The Sizewell C Project

8.1 Main Development Site Design and Access Statement Addendum

January 2021

Figure 2.4: Inheritance from Construction Masterplan (Indicative)

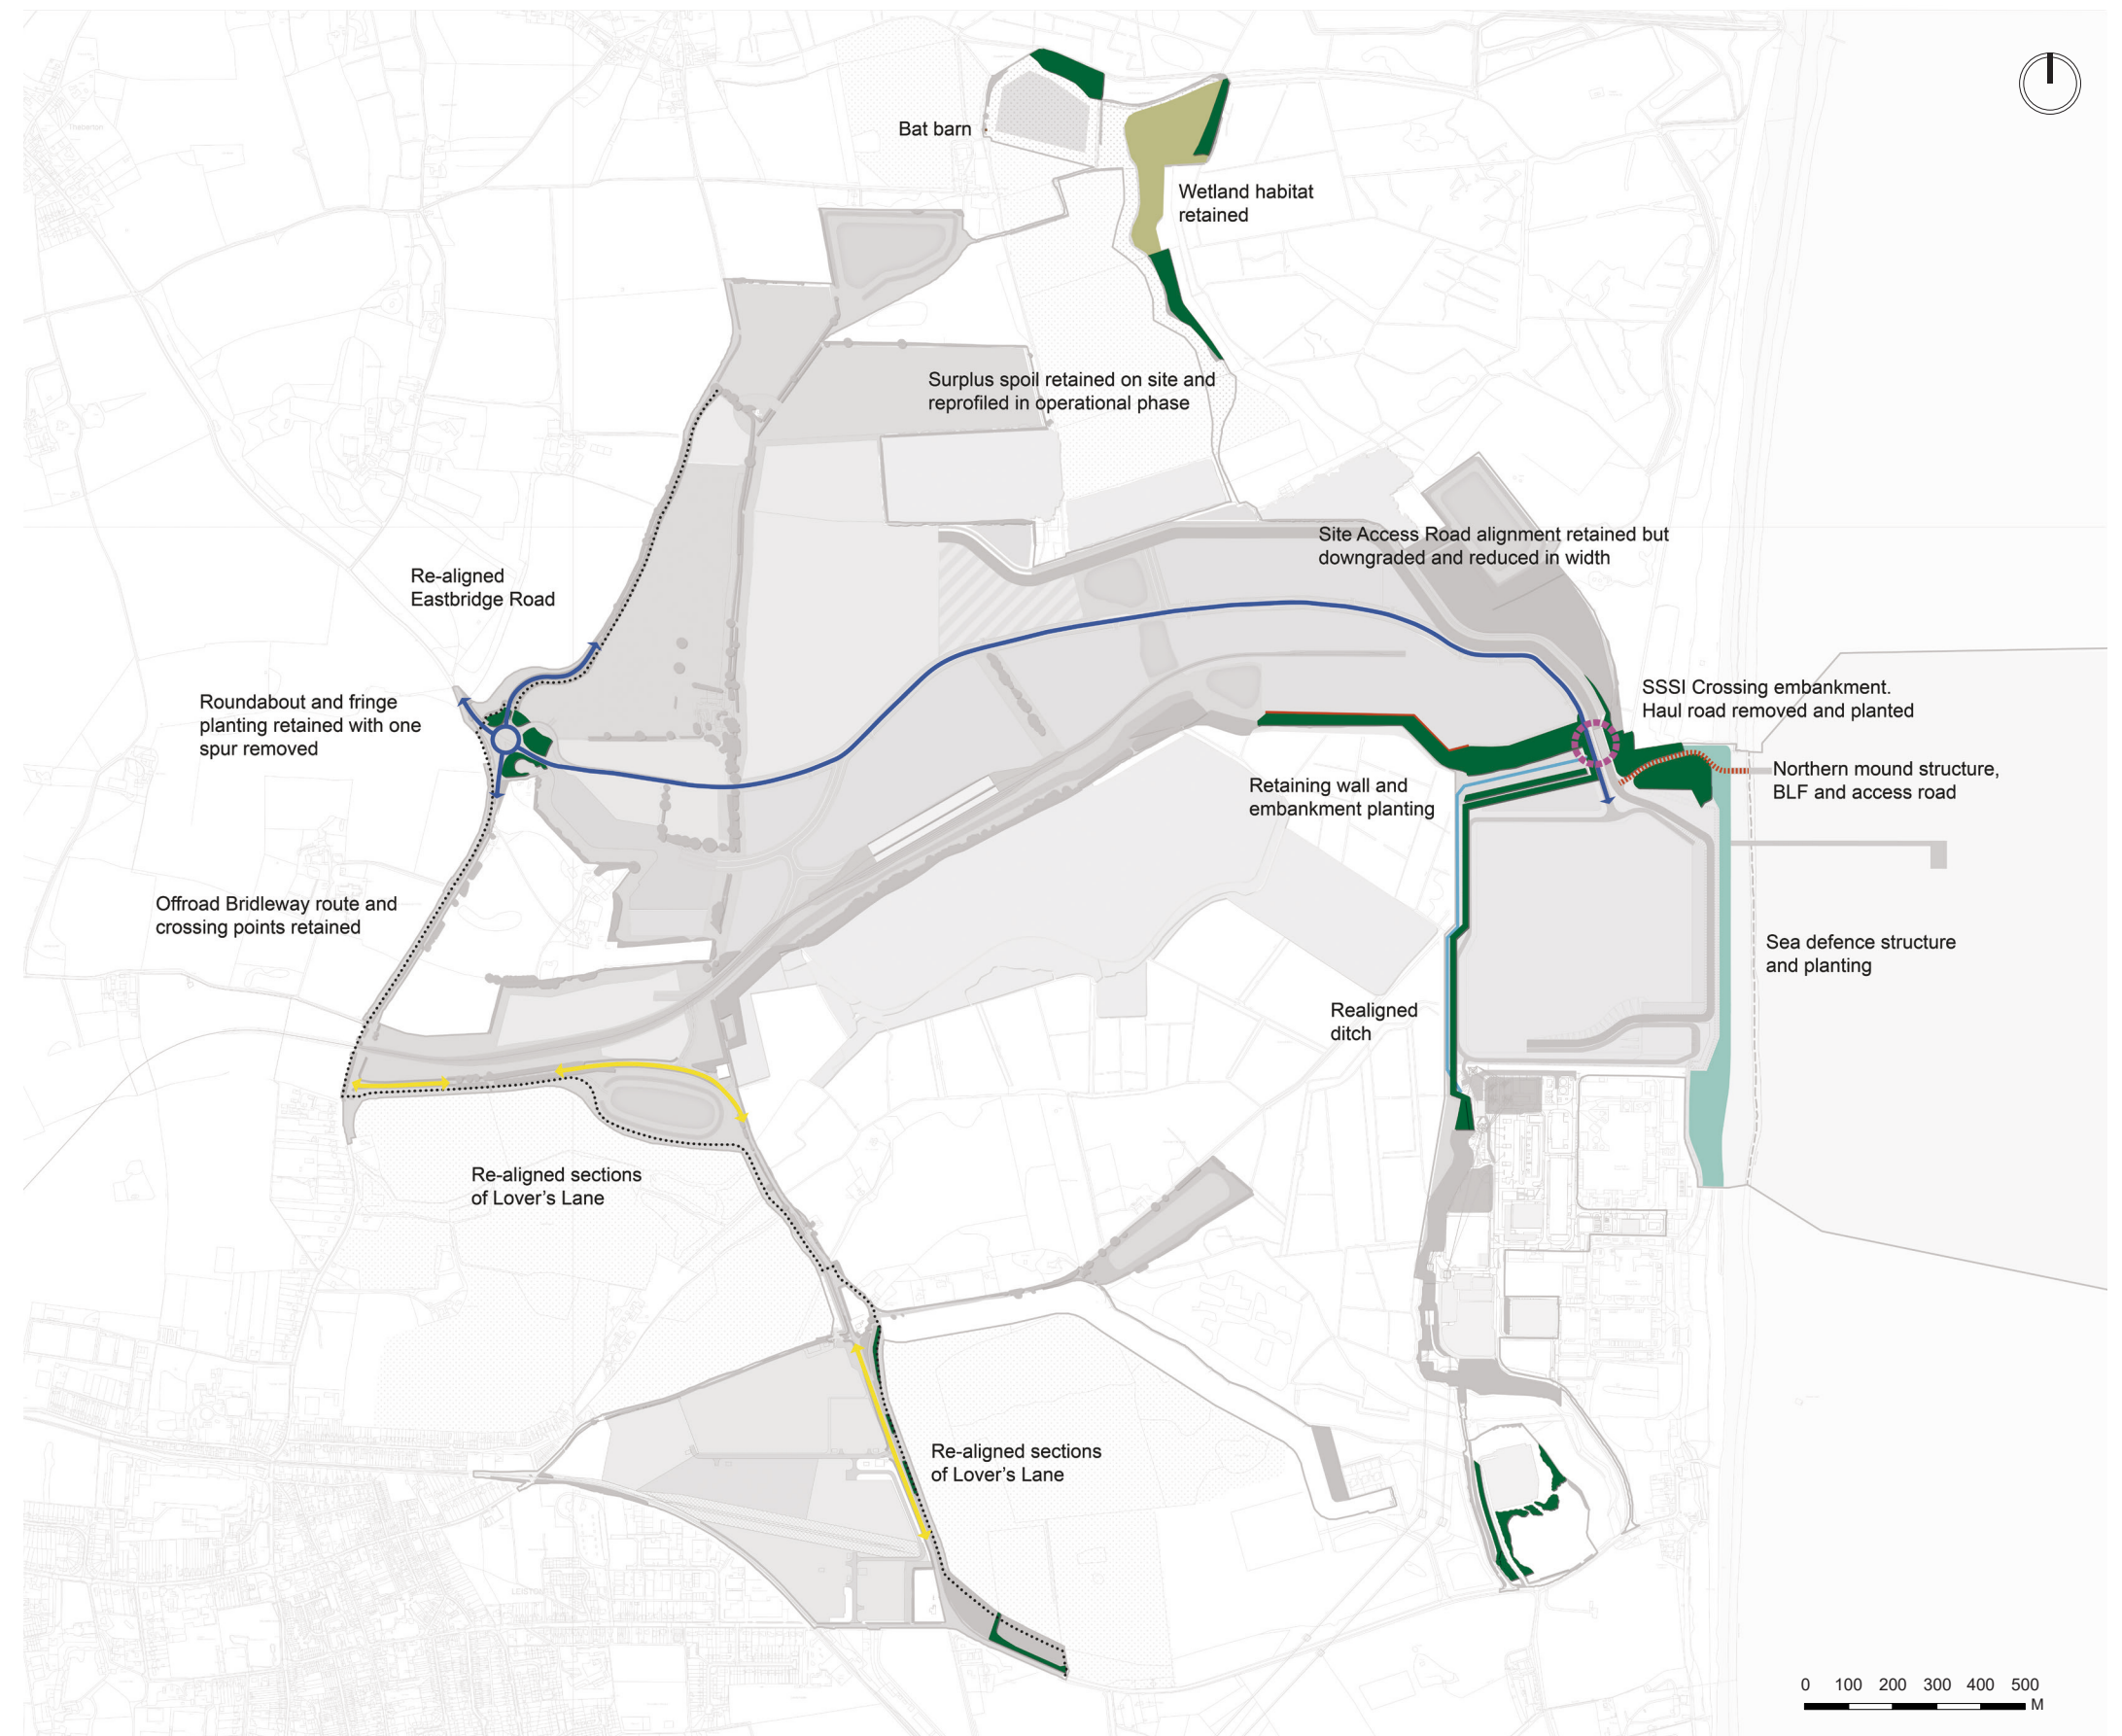
Figure 2.4 illustrates the landscape proposals which have been added to or changed within the Landscape Masterplan that are implemented at the construction stage. These are summarised in **Table 1**.

Figure 2.5: Planting character zones

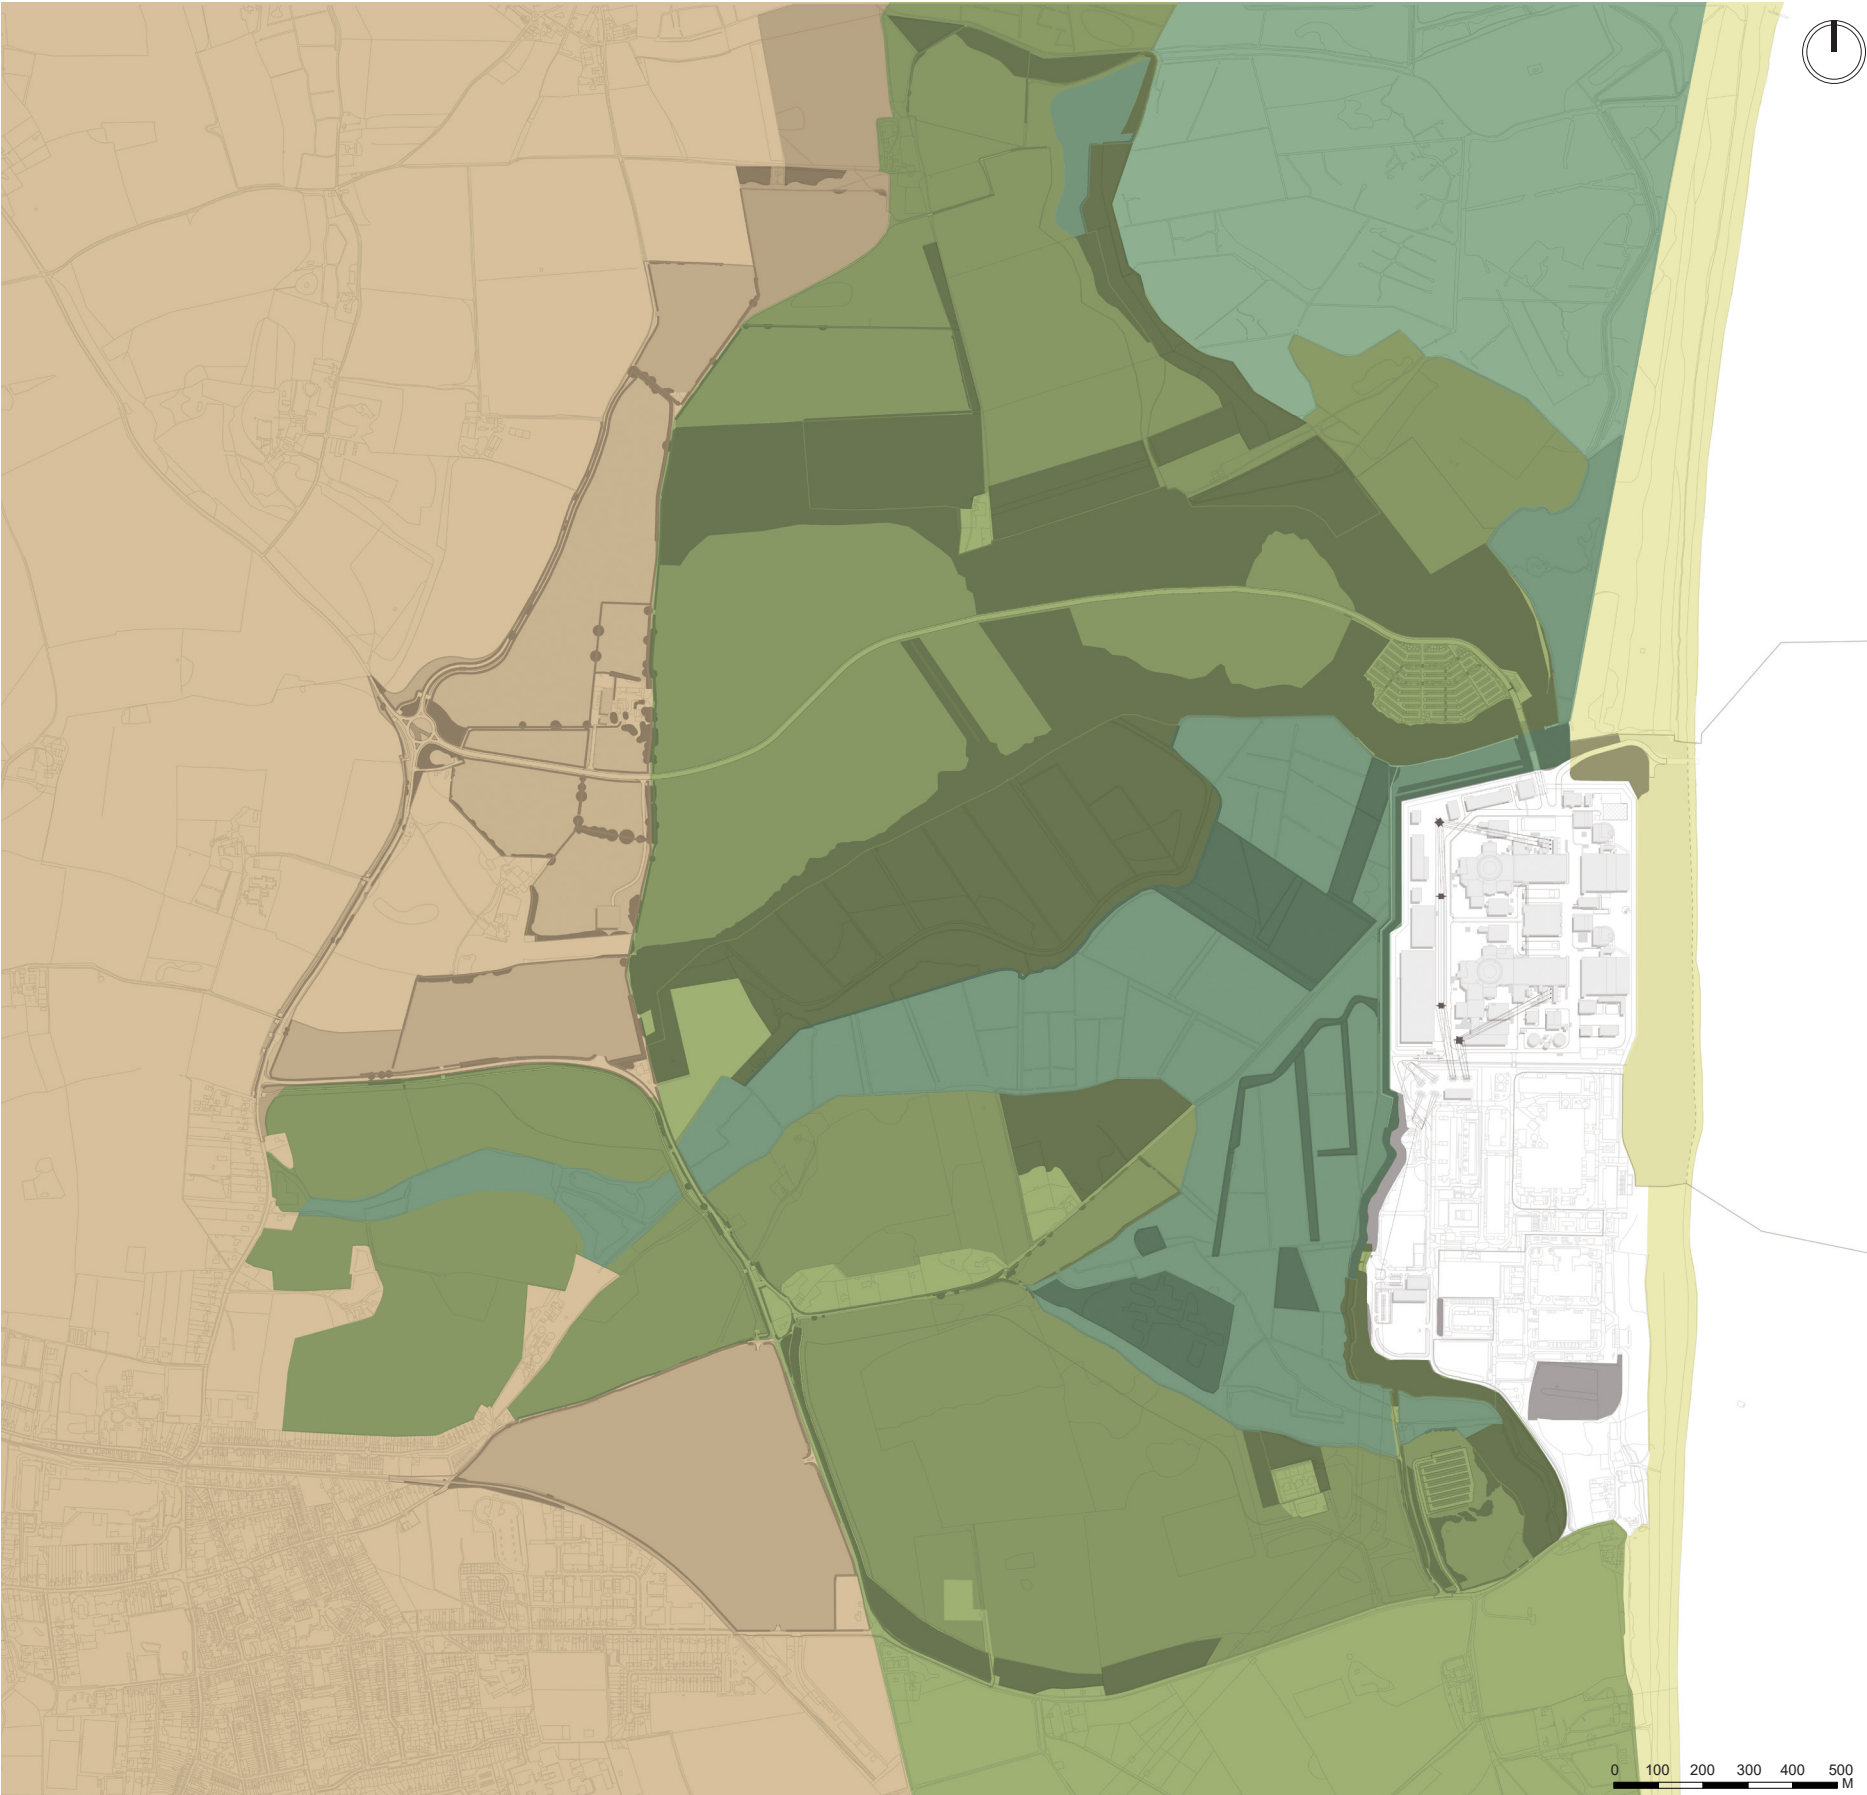
- 2.3.4 The creation of flood mitigation and wetland habitat areas would result in a minor alteration to the spatial extent of the Dry Sandlings Grassland and Coastal Levels character zones, as shown in **Figure 2.5**.

Figure 2.7: Rights of way and access - operational phase (Indicative)

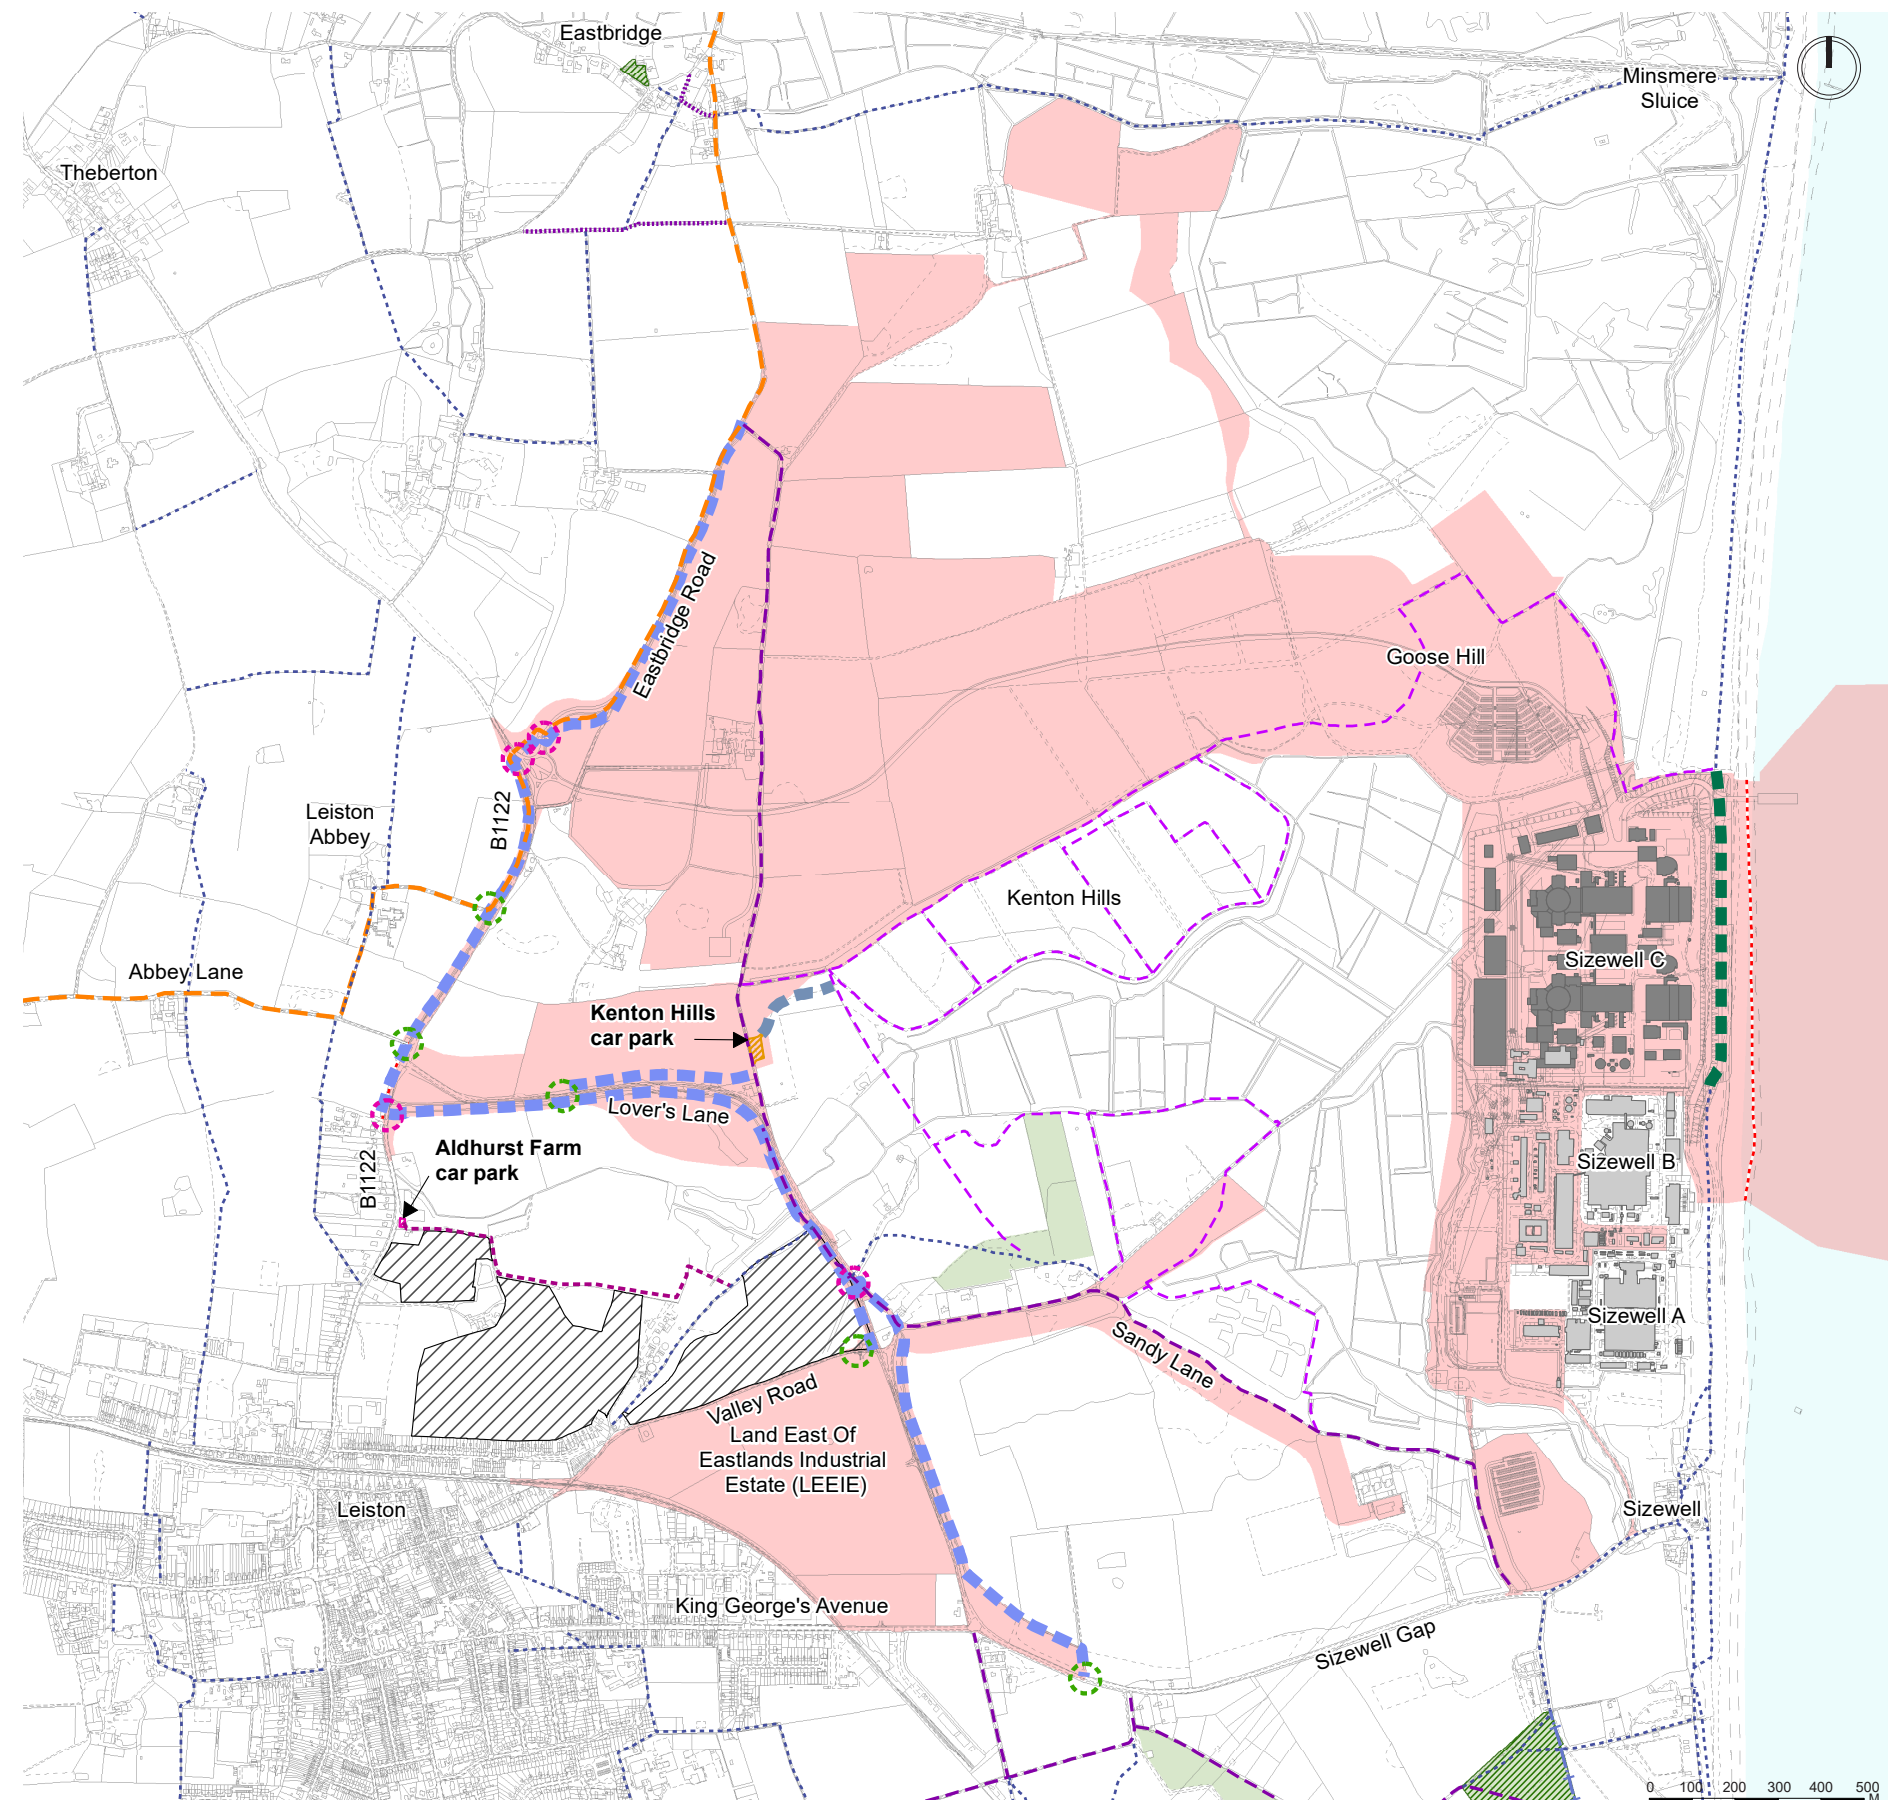
- 2.5.1 A new bridleway link would be created between Aldhurst Farm and Kenton Hills. This addition to the network has been requested by stakeholders and would comprise a crossing point over Lover’s Lane from the northern field of Aldhurst Farm into the arable field to the north. A new route would then pass through an existing field, parallel to the field boundary, towards Kenton Hills. It would then join the existing Bridleway 19 route, as shown in **Figure 2.7**.
